AIRWORTHINESS DIRECTIVE

Schleicher - ASW 20
All variants S/Nos 20001 through 20860, 20950 & 20951

Aileron flutter - preventative measures

SHEET: 1 of 4	ASW 20 Technical Note No. 31	Alexander Schleicher Segelflugzeugbau 6416 Poppenhausen
<p><u>Subject:</u> Preventive measure against aileron flutter.</p> <p><u>Serial number applicability:</u> All ASW 20 variants and serial nos. 20001 thru 20860; 20950 and 20951.</p> <p><u>Compliance:</u> Immediately, prior to the next take-off.</p> <p><u>Reason:</u> Recently two ASW 20s had aileron flutter in flap position 1 at a speed of about above 200 to 210 km/h. The said ASW 20s were improperly equipped with an elastic plastic tape to seal the gap between wing and flaps/ ailerons on the under sides; they used strips of tape which were insufficiently curved, and above all the teflon strip which has to lie underneath for sealing the gaps, was missing. Owing to this, air exchange between wing upper side and under side is possible which causes - depending on the control surfaces' deflection - periodical separation of airflow and this unusual kind of aileron flutter. These latest findings also account for earlier flutter incidents which occurred m

FIG.1

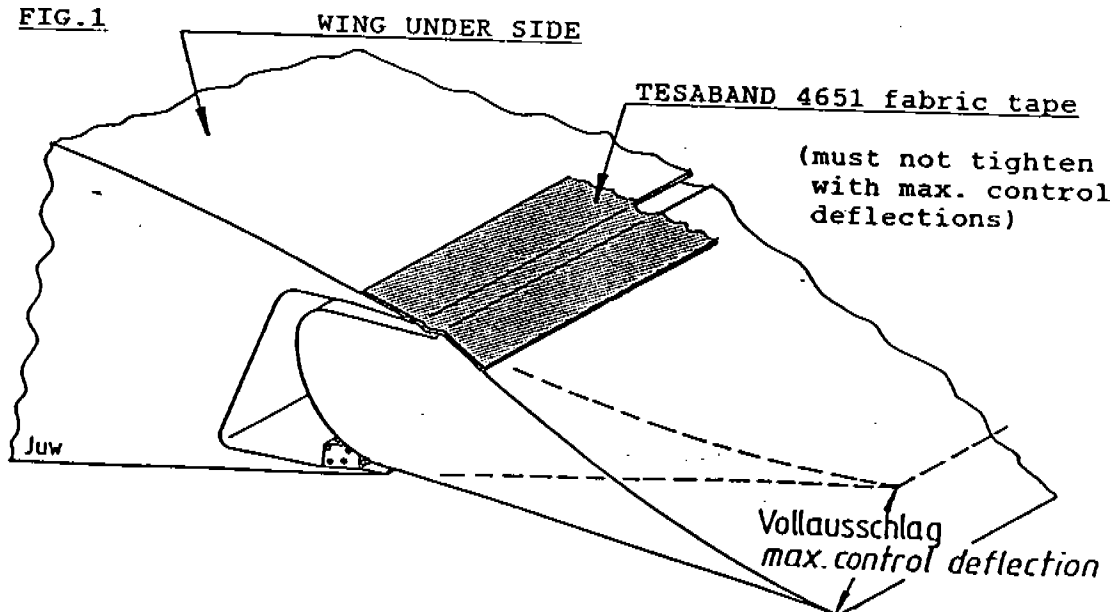
- 2.1 In case of the factory-standard fabric-tape TESA 4651, white, 38 mm wide, you have to regard the following in addition: if your glider is an ASW 20 or ASW 20 L you do not have to try to make a recess into the wing for the application of the TESA; just tape it onto the wing surface; according to the aerodynamics experts the relatively thick and wide fabric tape serves possibly also as a turbulator preventing laminar separation bubbles on the control surface under sides. But if your ASW 20 and ASW 20 L had already the fabric tape recessed into the wing contour, then you should apply a turbulator in addition (zig-zag or nap tape) which you have to fix directly in front of the fabric tape.

Fig. 2

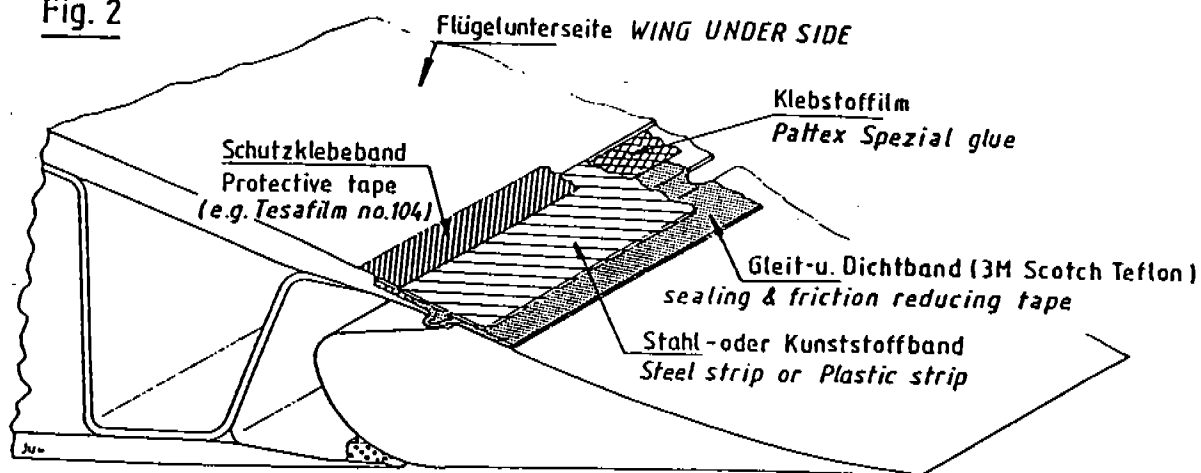
- 2.2 In case of the elastic lip sealing: this has to be renewed as shown in Fig.2, following the Maintenance Instruction J, Issue III; alternatively, the elastic lip sealing can be new applied instead of the above TESA tape sealing.
